Kurri Kurri Integrated Resource Recovery Centre

Response to Submissions Report

E230029 RP#23

March 2026

UNDERPINNING PIER & STRIP FOOTING DETAIL
SCALE 1:20

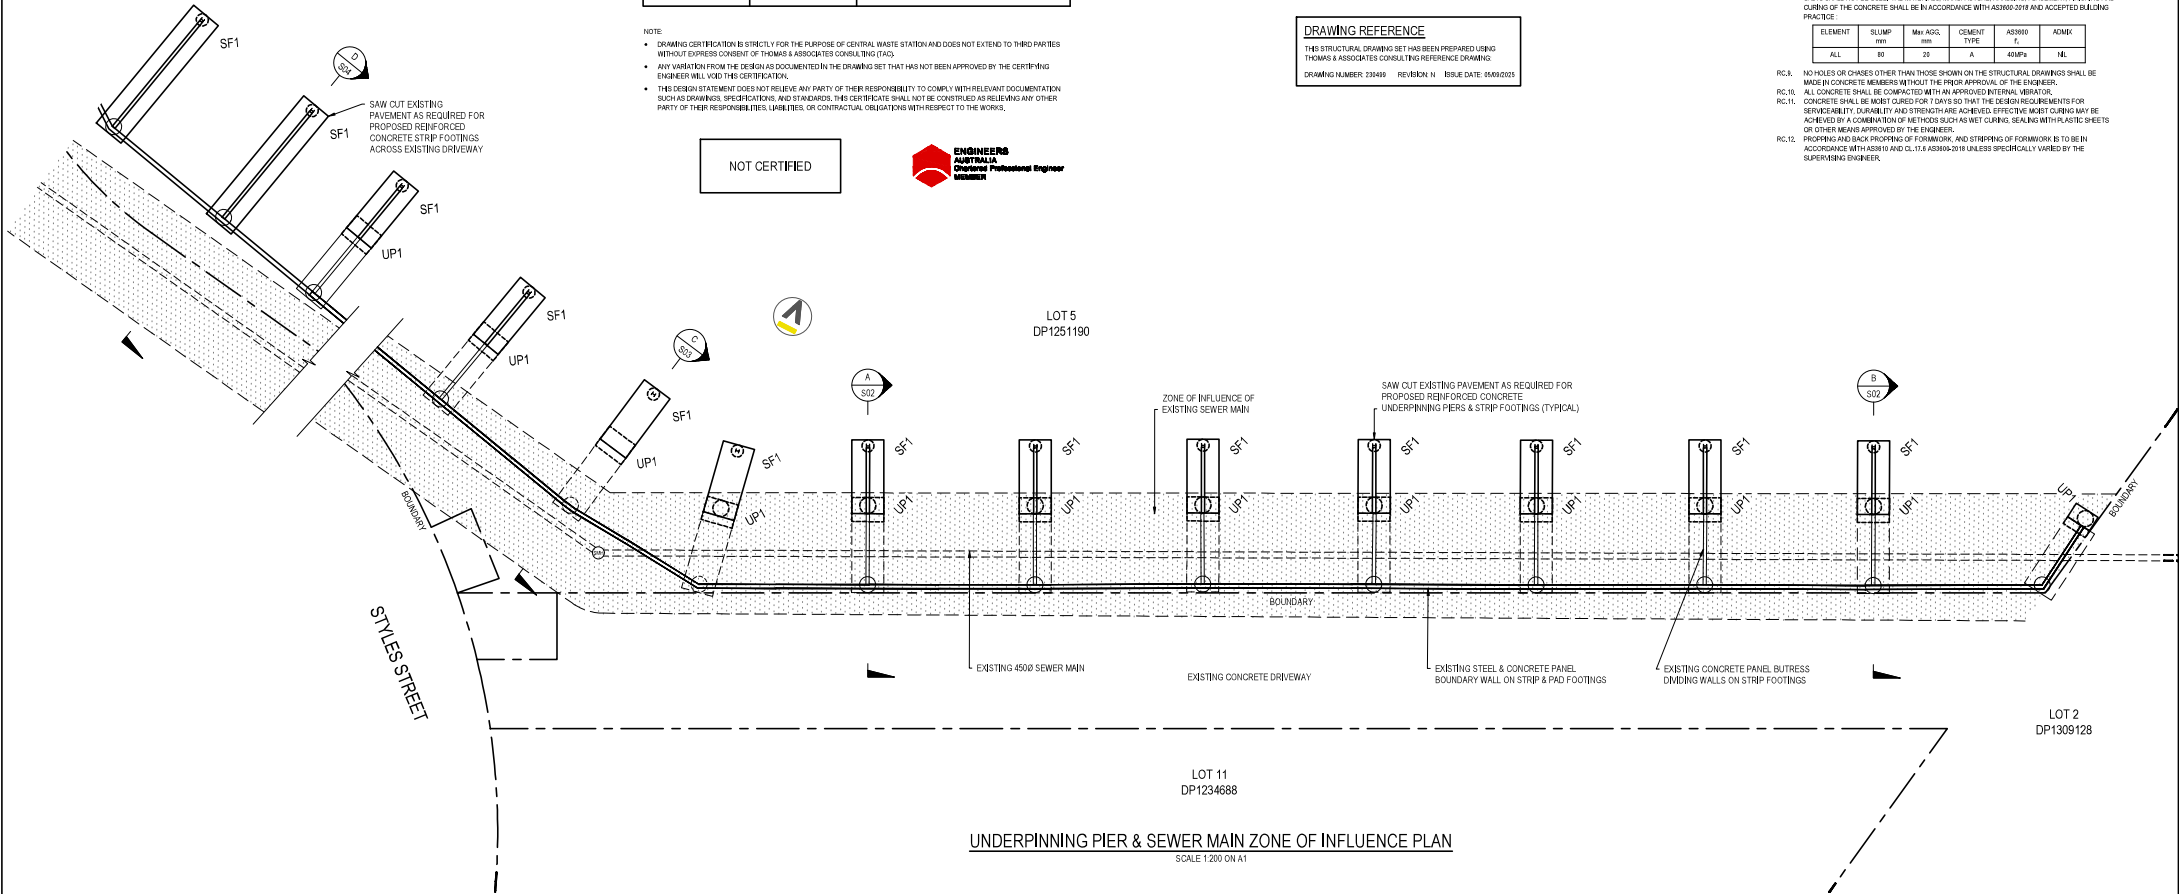
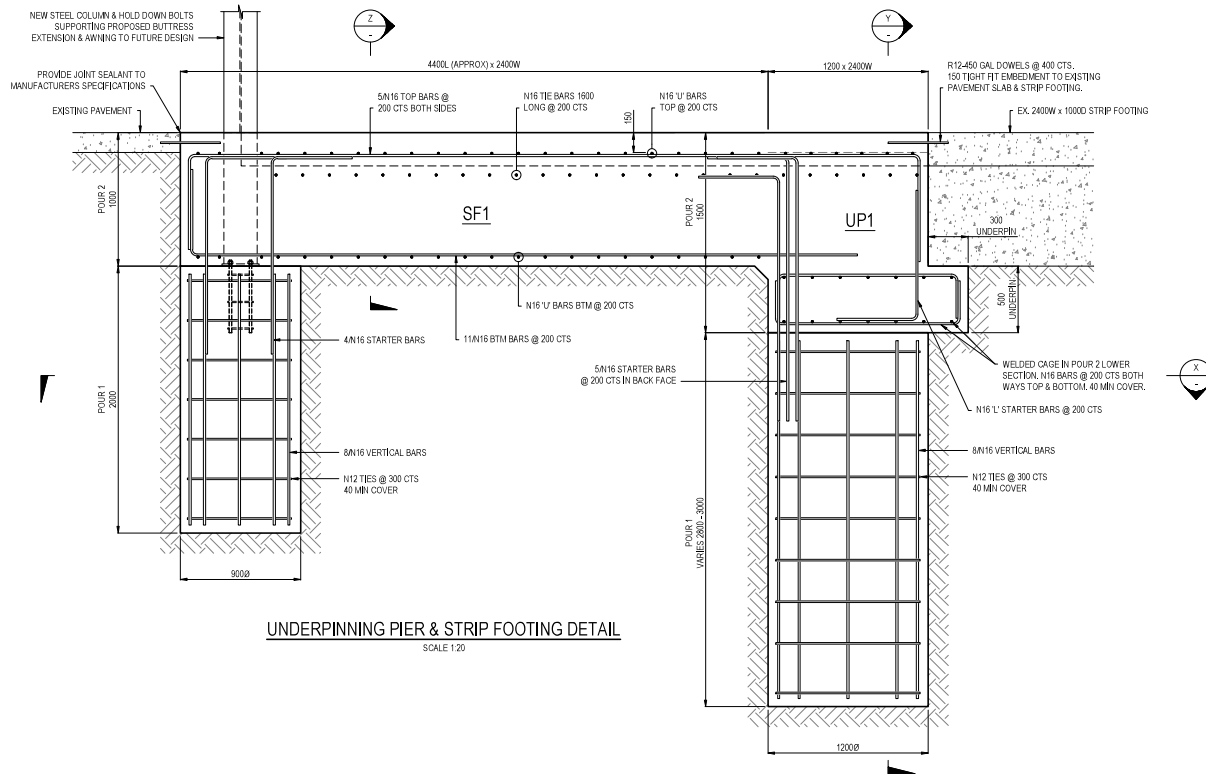
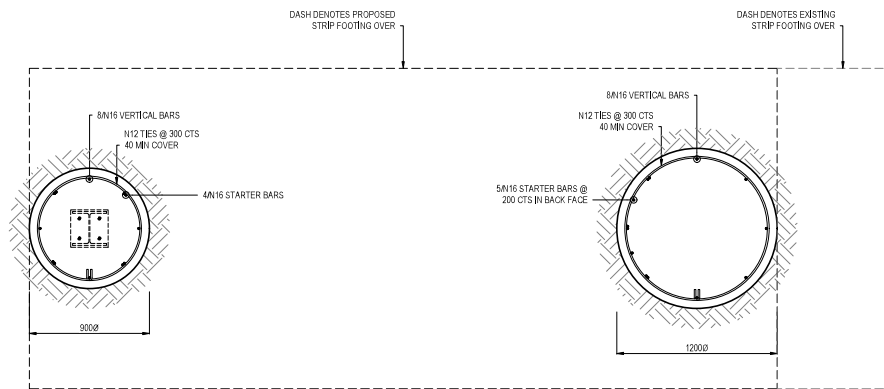
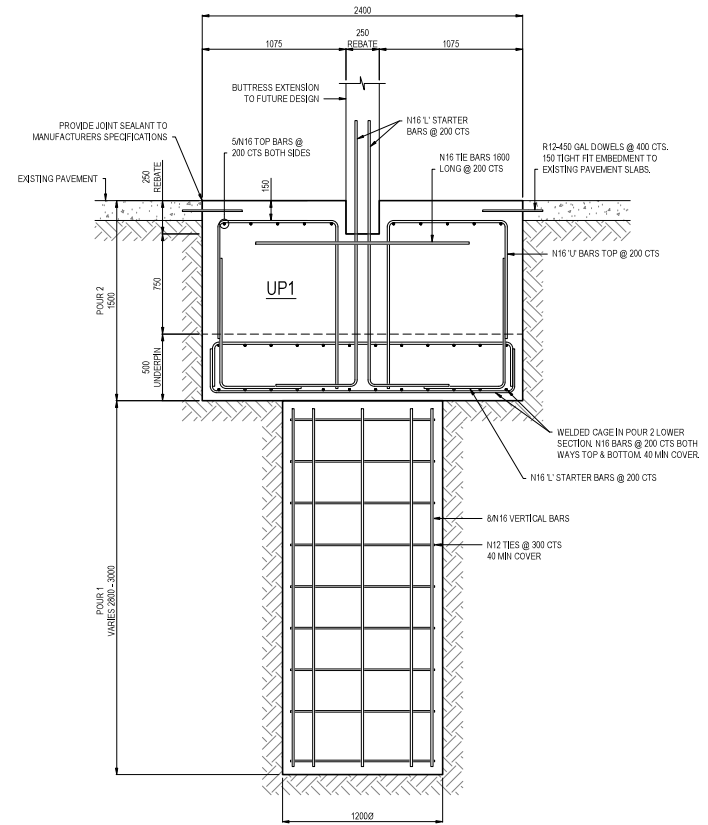
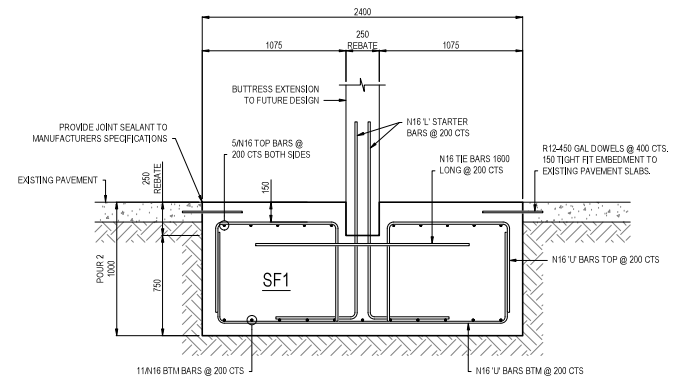
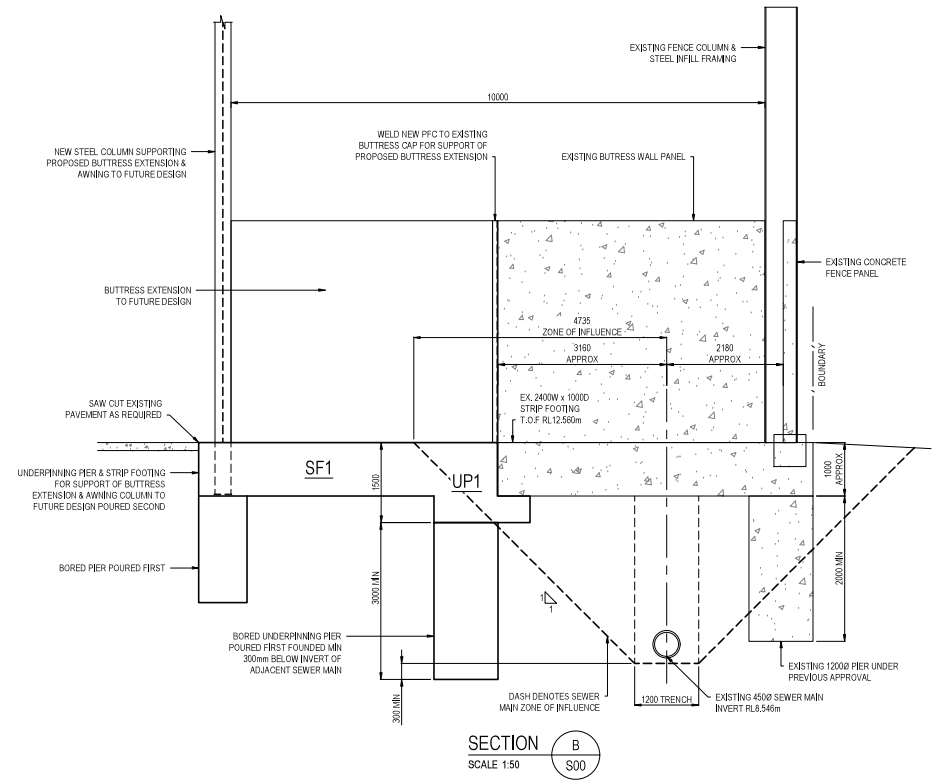
There appears to be 2x new longer SF 1 that is near the pipeline bends with no details (on the left side of the plan view drawings), have the designers confirmed the distance of piers to the sewer pipeline although it is not over the sewermain? And will it be the similar design as provided on their cross section. The cross sections only show the existing and new piers with pipeline in the middle.

Can you please submit a revised design for our review.

Hunter Water accepts the footing design as shown on Thomas Engineering Plan Underpinning Pier Plan, Notes & Drawing Certification (Issue E; dated 11/02/2026.

- The existing piers have been constructed in accordance with a previously approved DA, and therefore reflect the footing depths that were assessed and accepted at the time of approval.
- The attached updated structural plans for the new footings now clearly demonstrate that all new/proposed piers are founded below the sewer invert level/Zone of influence, consistent with Hunter Water's request/requirements.

CWS Kurri Kurri Integrated
Resource Recovery Centre
Environmental Impact Statement
Figure F.1

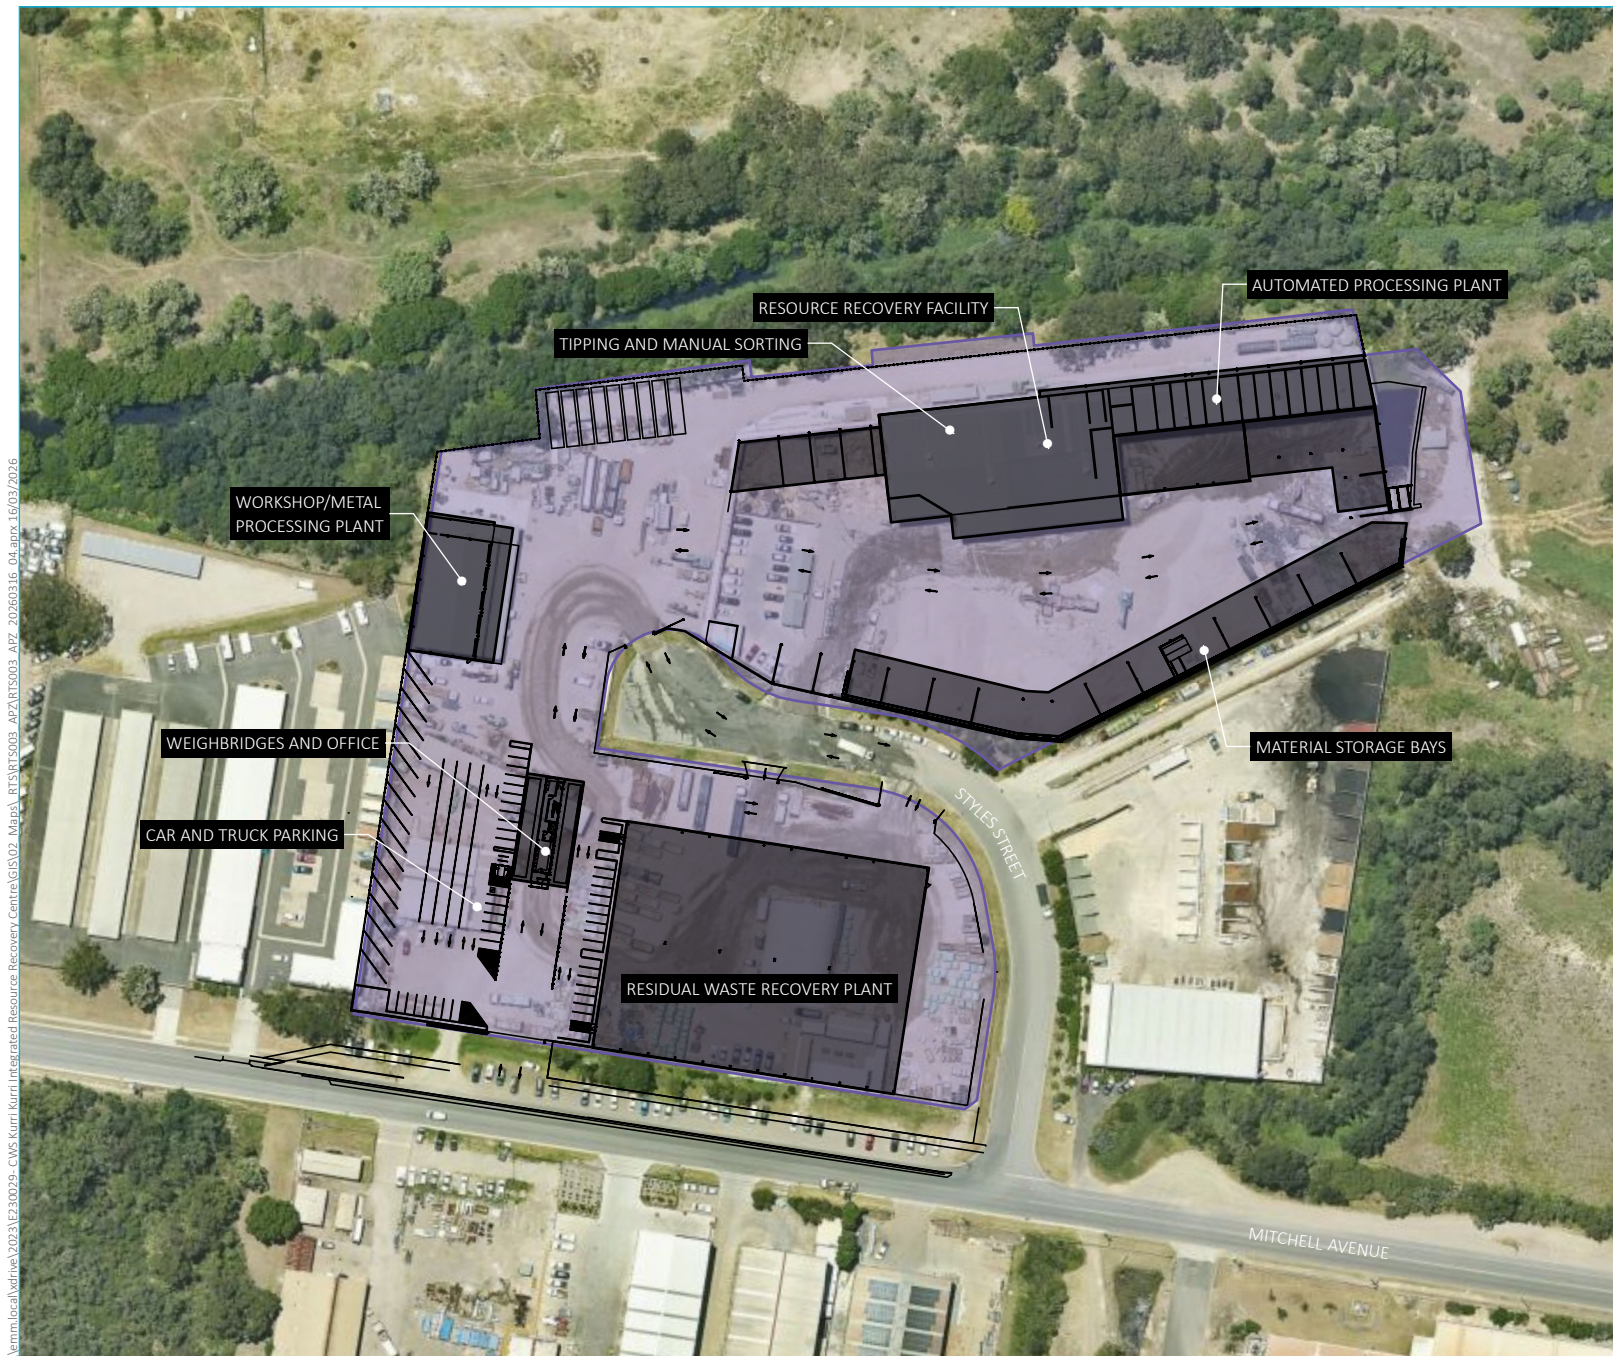
RFS provided comments on the bushfire assessment submitted with the EIS. The Bushfire Assessment Report for the EIS (Appendix I.6) was prepared by Cool Burn Pty Ltd. Cool Burn has reviewed the RFS advice and prepared a response, provided in Appendix F. A summary of the responses to Items 1 to 3 of the RFS submission is provided below.

A figure illustrating the proposed APZ arrangement is provided in Figure 4.5. The mitigation measure for bushfire has been updated to reflect this update.

It is noted that “Restriction B” shown on the plans prepared by Thomas and Associates reflects a restriction carried through from the surveyor’s information, related to drainage easements. These are not related to APZ. Cool Burn, an appropriately qualified bushfire consultant, has assessed the proposed IRRC and confirmed that an APZ of 12 m is appropriate along the northern boundary of the site.

Bushfire	
B1	Asset protection zones (APZ): <u>The property will be managed as an APZ, for 12 m from existing buildings to the north and up to the property boundary in all other directions (refer to Figure 4.5 of this RtS report).</u> - The APZs will be maintained while the site continues to be used as a waste management facility. <u>Management within the APZ will include:</u> <u>tree canopy cover will be less than 15% at maturity</u> <u>trees at maturity will not touch or overhang the building</u> <u>lower limbs will be removed up to a height of 2 m above the ground</u> <u>tree canopies will be separated by 2 to 5 m</u> <u>preference will be given to smooth barked and evergreen trees</u> <u>large discontinuities or gaps in vegetation will be provided to slow down or break the progress of fire towards buildings</u> <u>shrubs will not be located under trees</u> <u>shrubs will not form more than 10% ground cover</u> <u>clumps of shrubs will be separated from exposed windows and doors by a distance of at least twice the height of the vegetation</u> <u>grass will be kept mown (as a guide grass should be kept to no more than 100 millimetres (mm) in height)</u> <u>leaves and vegetation debris will be removed.</u>

Figure 2.2 Modified water management system schematic (changes highlighted in red box)

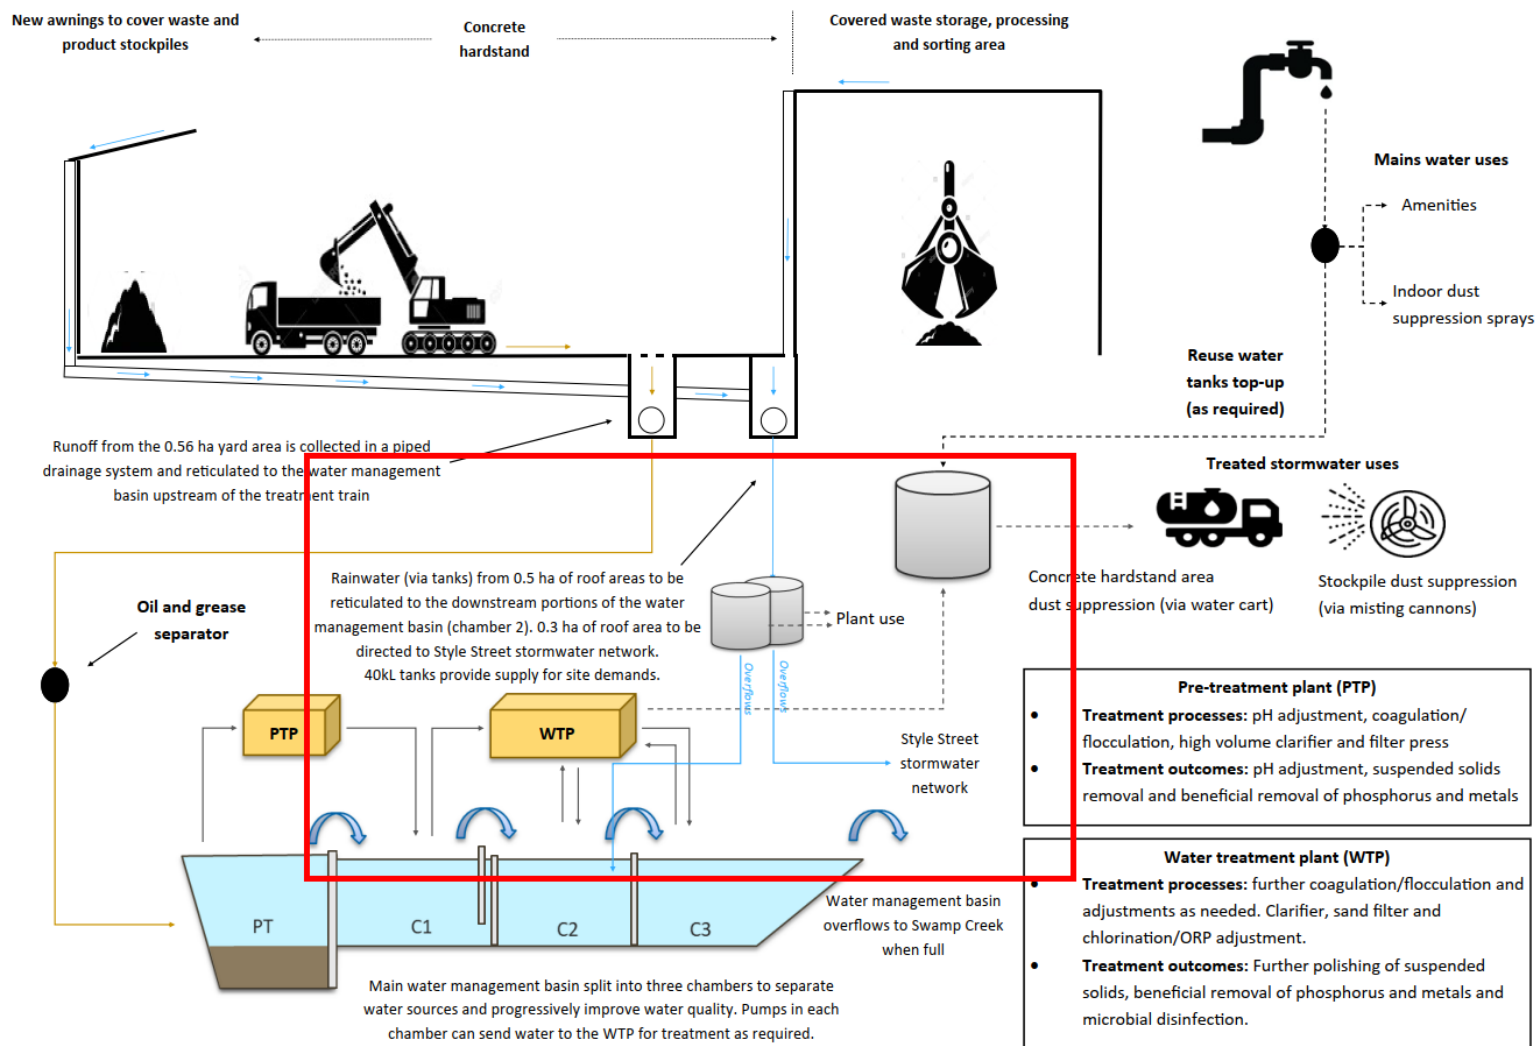
- demonstrate that all reasonable measures to prevent, control, abate, or mitigate pollution have been considered, including storage capacity and diversion of clean stormwater
- provide estimates of treated water quality for key pollutants.

The water management system schematic (as presented in Figure 5.2 in the Water Assessment) was modified and is presented in Figure 2.2.
